Docket No. 50-423
B11118

Millstone Nuclear Power Station, Unit No. 3
Transmittal of Responses to Structural Audit Items

The attached responses are provided to close out Items 8, 14, 15, and 25 from the NRC Structural Audit of February 27 through March 2, 1984.

FIGURE 15-4

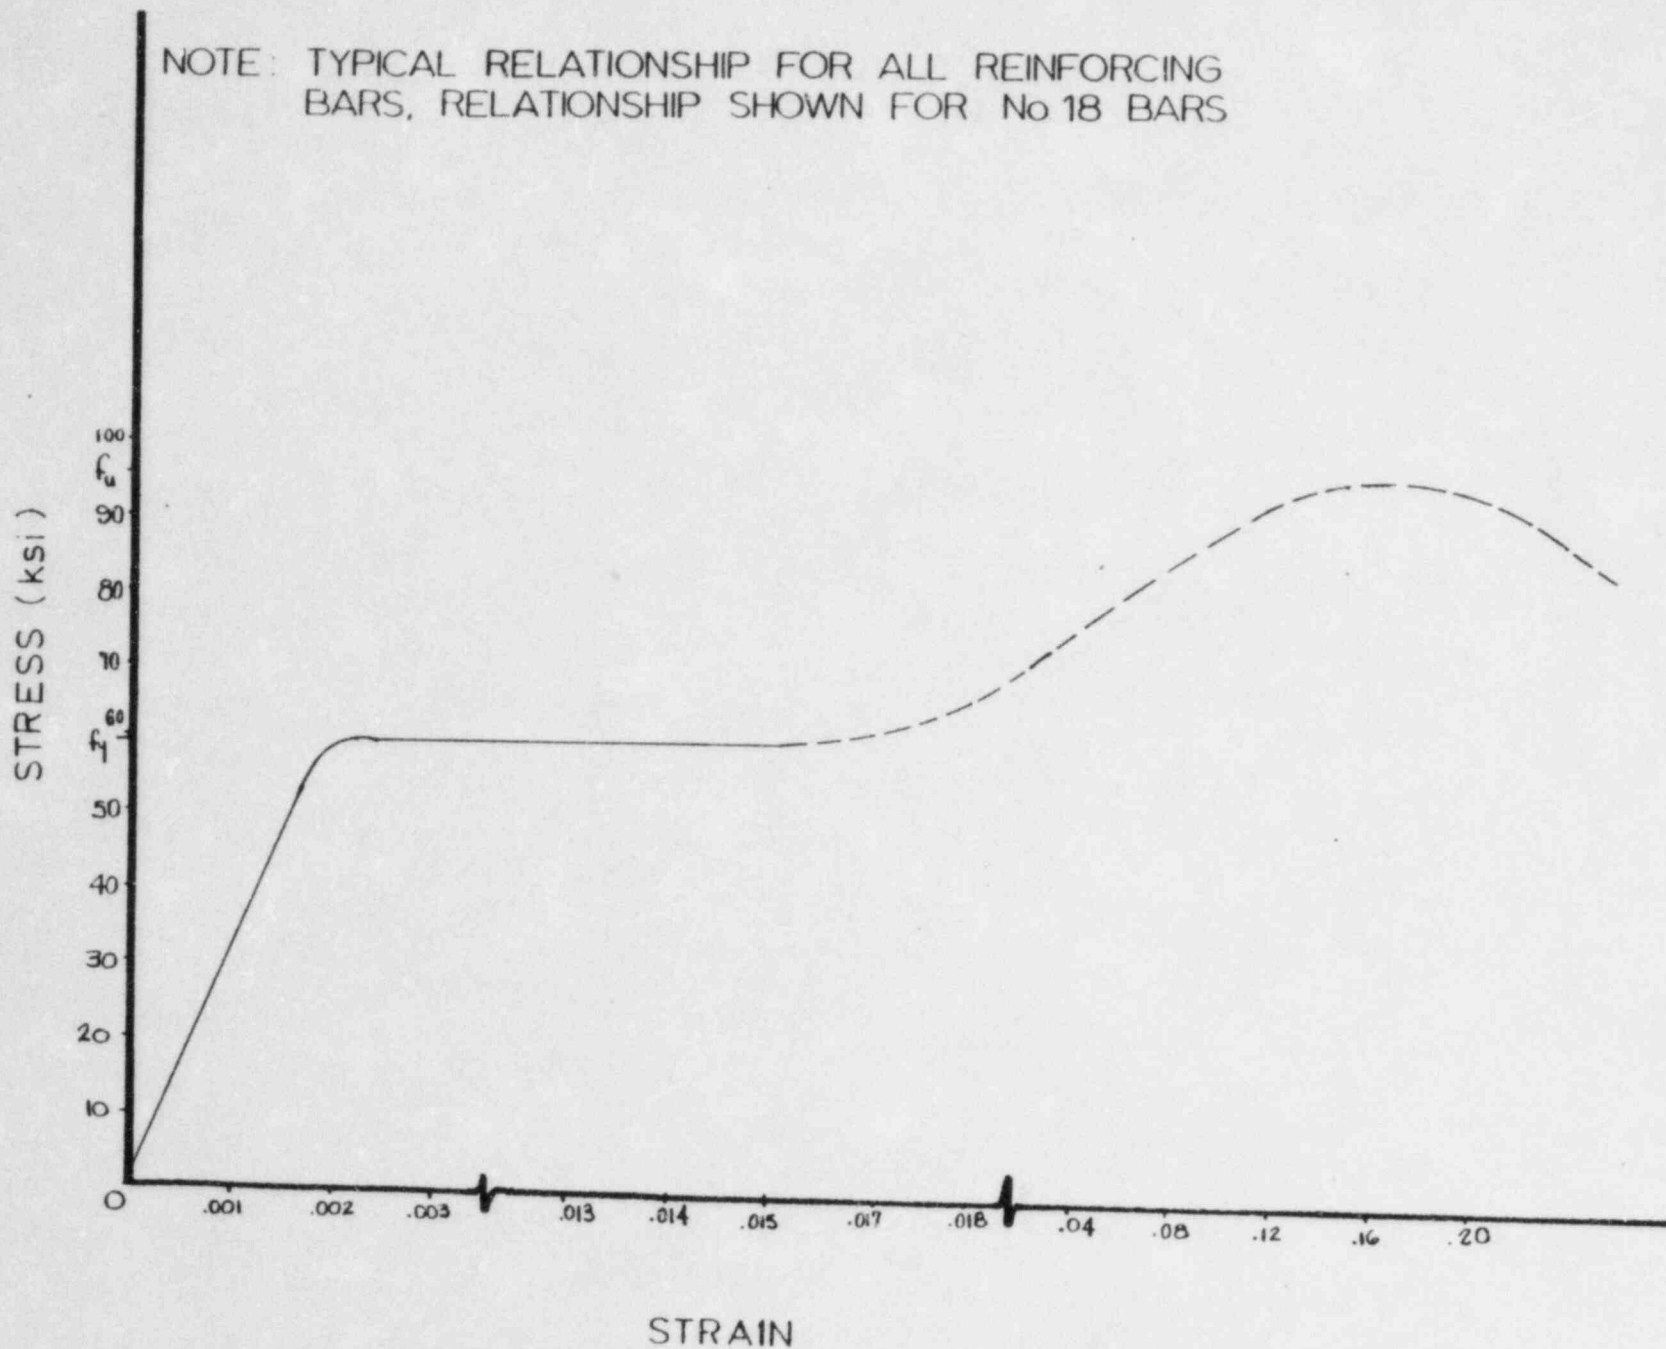
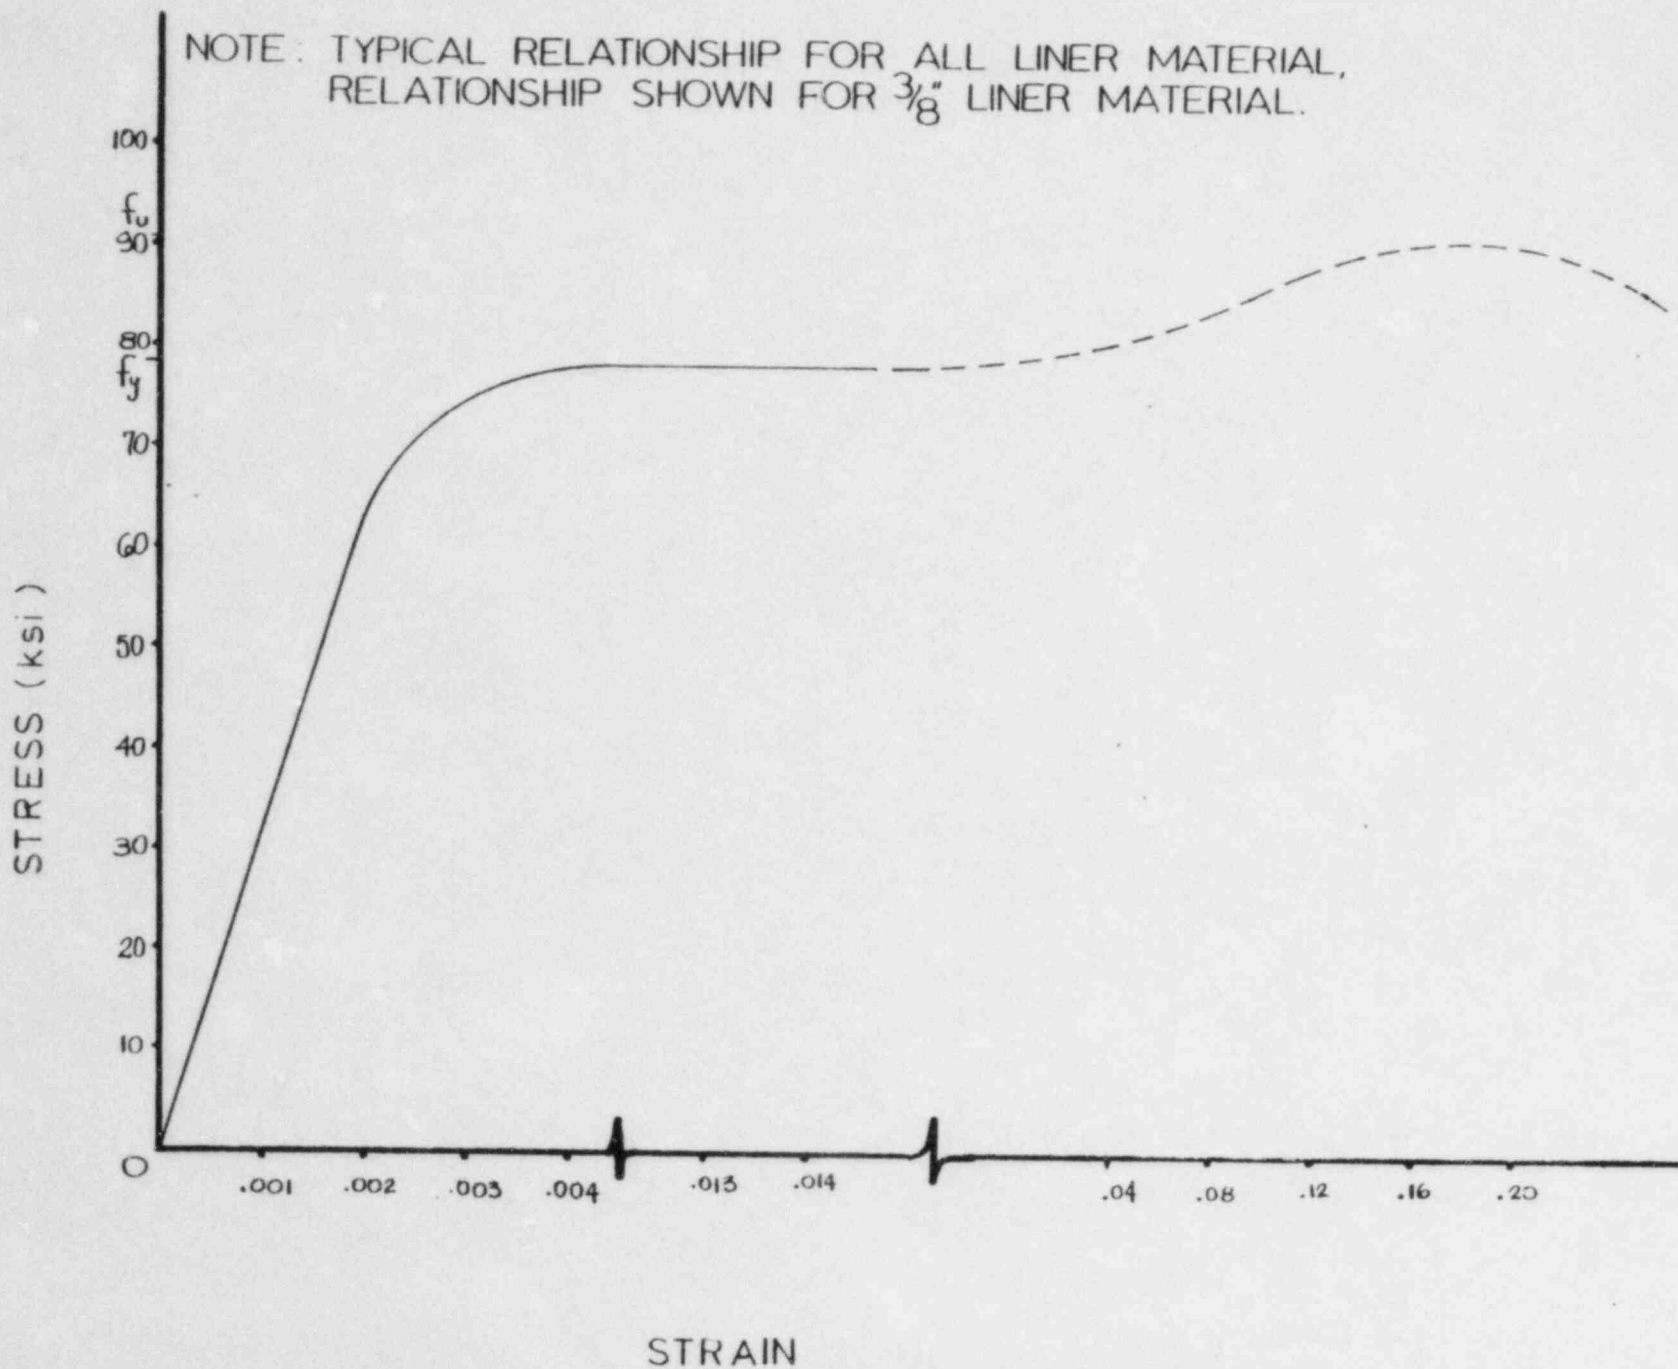
- (i) Were elements that yielded prior to final yielding continuously checked to ensure that they were within acceptable ductility limits?

Figure 15-4 - Stress-strain curve for reinforcement and liner.
and 15-5

With constant strain across the section, the pseudo-nonlinear method as described in Section 3.2.3 of the Containment Failure Modes Report predicts the point of a general state of yield at a strain of approximately 0.005, well within the ductile range of the liner and reinforcing steel material (see figures 15-4, 15-5).

Figure 15-6

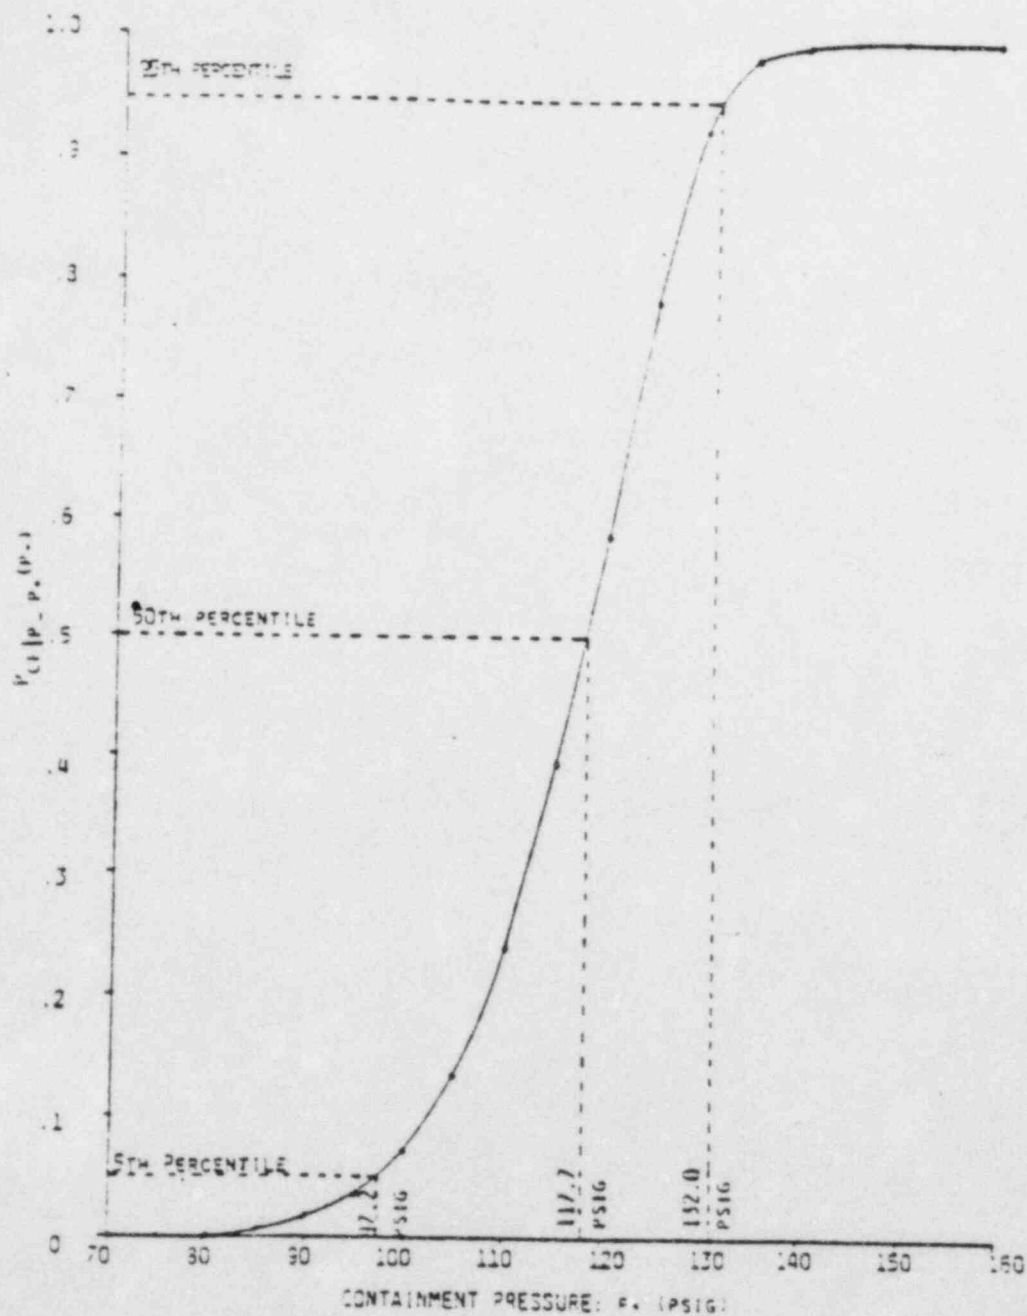
- (ii) Provide justification to indicate why the calculated ultimate pressure is the median of the probability distribution.

The resulting probability distribution, combining all the significant modes of failure, is presented in Figure 15-6. This cumulative distribution curve (Weibull distribution) represents the net conditional containmentment failure probability yielding a 5th, 50th, and 95th percentile failure pressure as indicated.
